June 30, 2017

Saint Paul Planning Commission
Betsy Reveal, Chair
15 Kellogg Blvd. West
Saint Paul, MN 55102

RE: Ford Site Zoning and Public Realm Plan

Figure 1

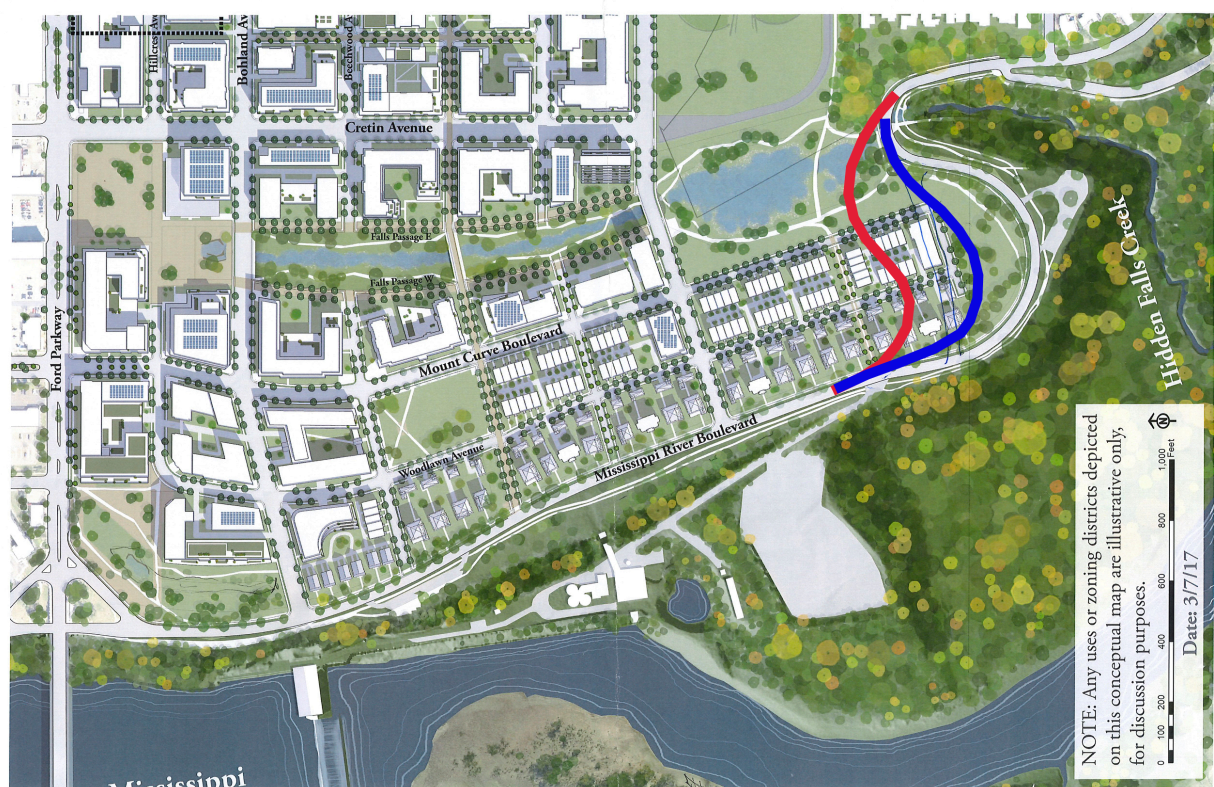
expanded." (Ford Site Open Space Guidelines) FMR believes this is a missed opportunity of the Zoning and Public Realm Plan. The existing strip of parkland on top of the bluff and riverward of Mississippi River Boulevard is very narrow, leaving little room for park activities, overlooks, picnic facilities, etc. that new residents of the Ford site as well as regional visitors might desire. We join the Ford Site Task Force in recommending that the City realign Mississippi River Boulevard to the east at the south end of the site to create a more contiguous and expansive bluff top park.

Figure one (below) illustrates two possible realignments of Mississippi River Boulevard (MRB). In the blue realignment scenario, approximately 2.3 additional acres of parkland would be created at the bluff top and consolidated riverward of MRB. This would mean that approximately 1.4 acres of parkland could be added elsewhere in the site.

In the red realignment scenario, approximately 6.5 additional acres of parkland would be created at the bluff top and consolidated riverward of MRB. This would allow approximately 2.9 acres of parkland to be added elsewhere in the site.
